Access Compliance Report Public Rights-of-Way (Curb Ramps)

Main Street: ANTONIO_PKWY Cross Street: AVENDALE_BLVD Location: SW

ADA ID: RPRK211115172449 Ramp Type: Type 1 - Perpendicular Diagonal Initial Pass/Fail: Fail Overall Compliance: No Severity Score: 15

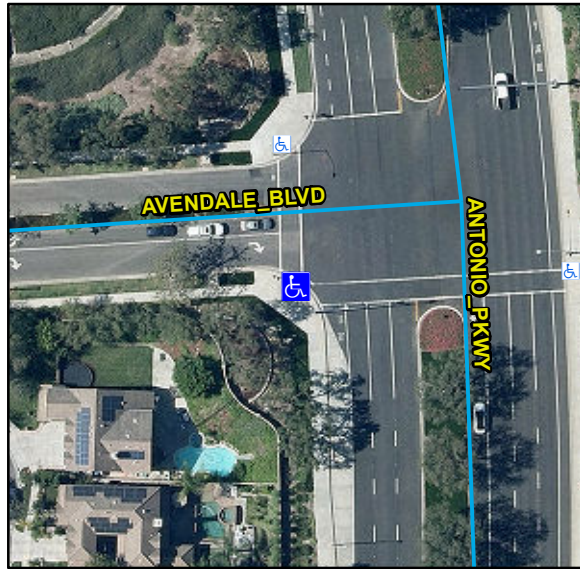
R304.2.2, R204.3, R304.5.3, STD 1115

Remove & Replace Curb Ramp With Two New Directional Ramps or Equivalent.
